PLANNING DEPARTMENT – Development Review Services

February 17, 2017

RE: **North Towne Plaza**  
**Drainage and Grading Plan**  
**Engineer's Stamp Date 12-9-2016 (File: E19D033)**

C201

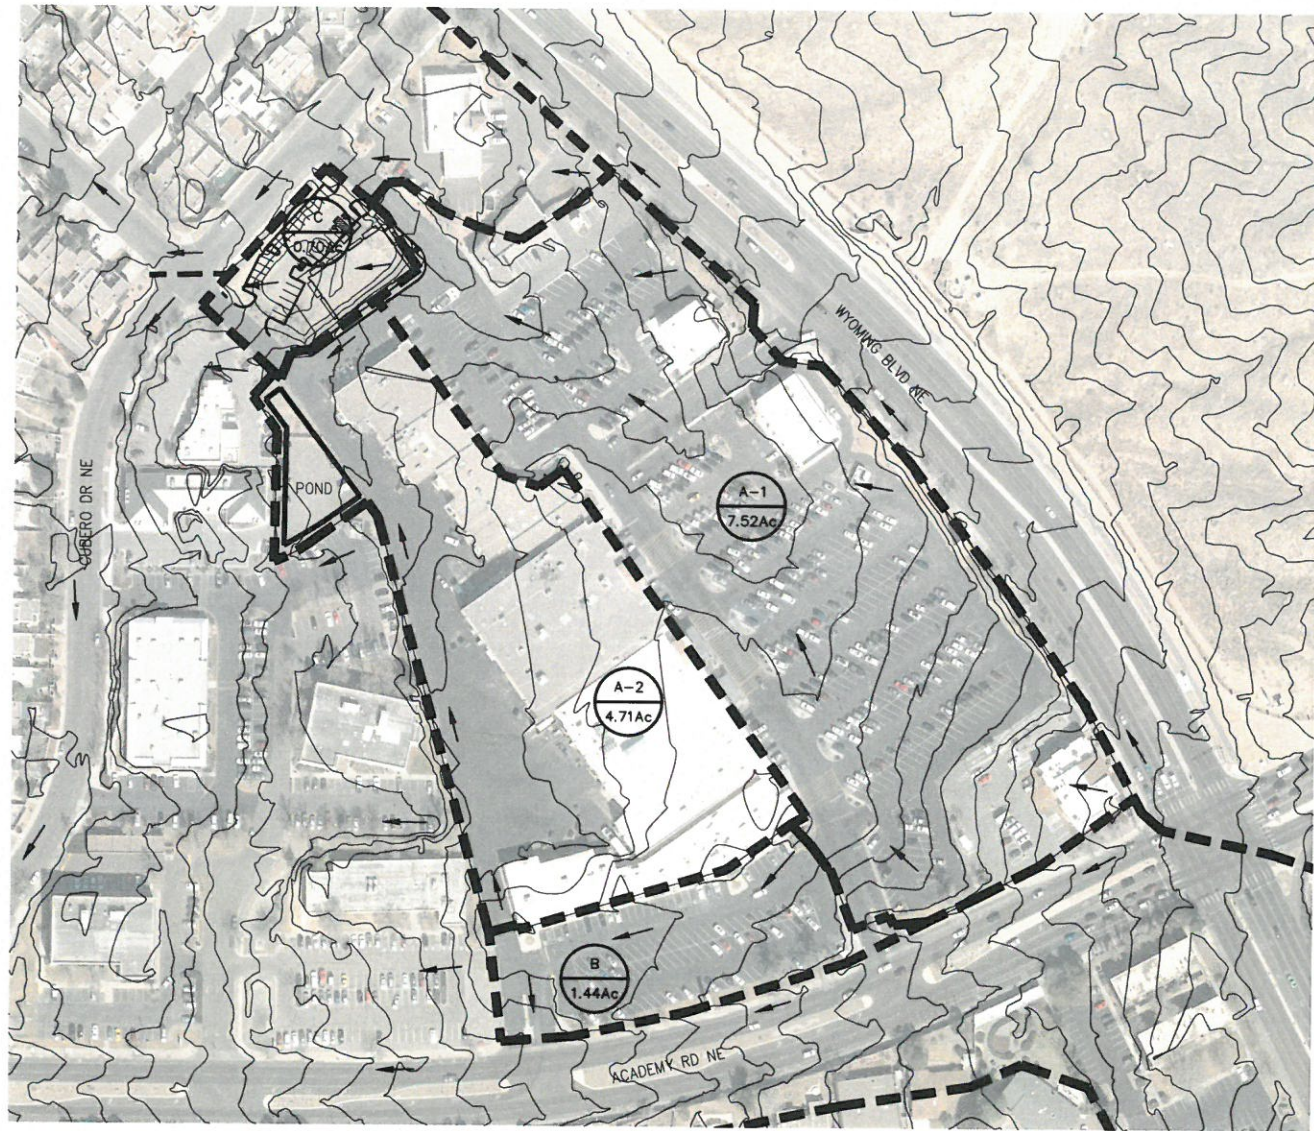
Need easement
